TECNICAL BULLETIN 9

TECHNICAL BULLETIN NR 9

Subject: Light paper feeding kit for **Multi Air** top feeding machines

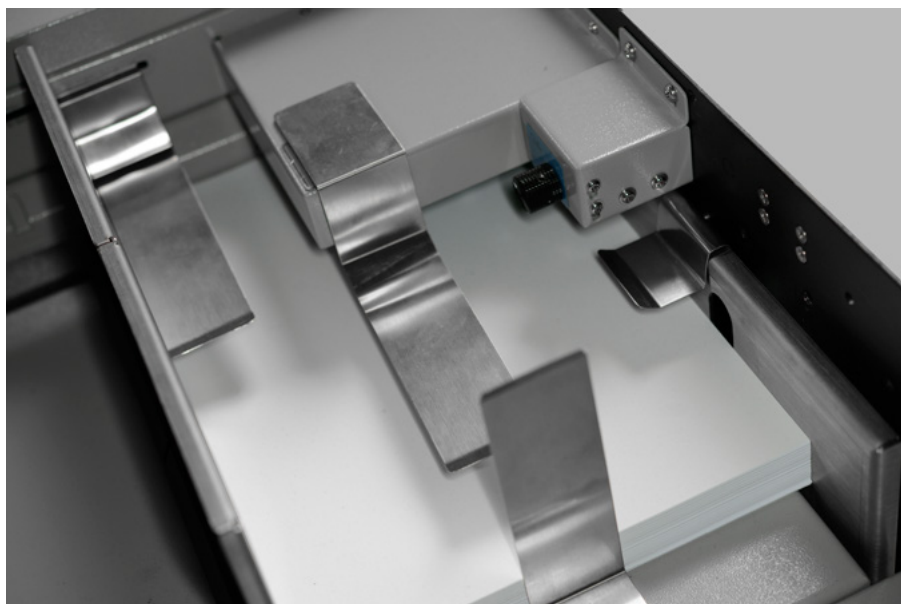
Simple guide kit consisting stainless steel strip guides x5 pcs

This will guide most light and mid weight papers perfectly

The picture attached shows the correct installation of the guides

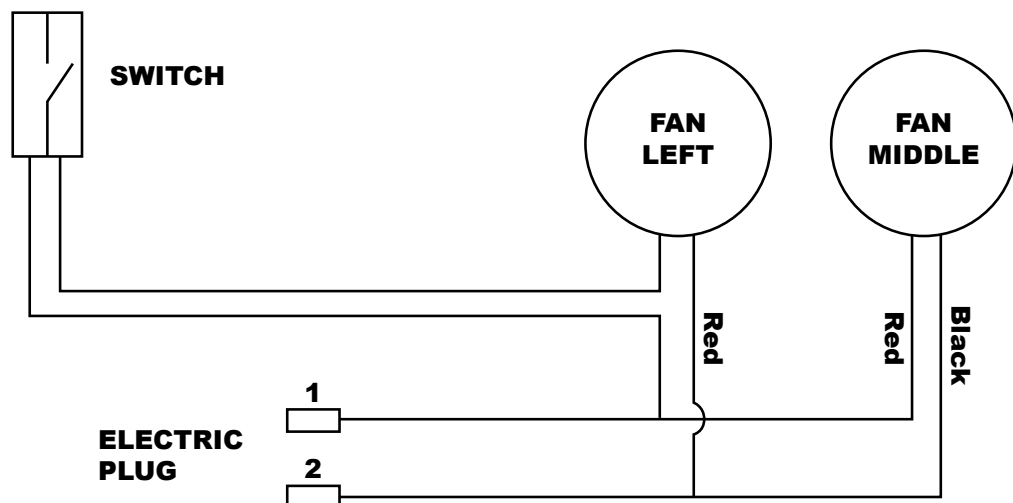
Advanced guide kit comprising of the above and 2 minor machine modifications that can be done at your office or in our tech repair centre in Soest Holland

The machine modifications are :

- 1- Drilling and tapping 2x M4 holes to raise the tray detector switch block by ca 5mm
- 2- Adding a hole in the back cover 12x12 mm to accept a rocker switch to cut out nr 2 blower fan to reduce the amount air blast on light paper.
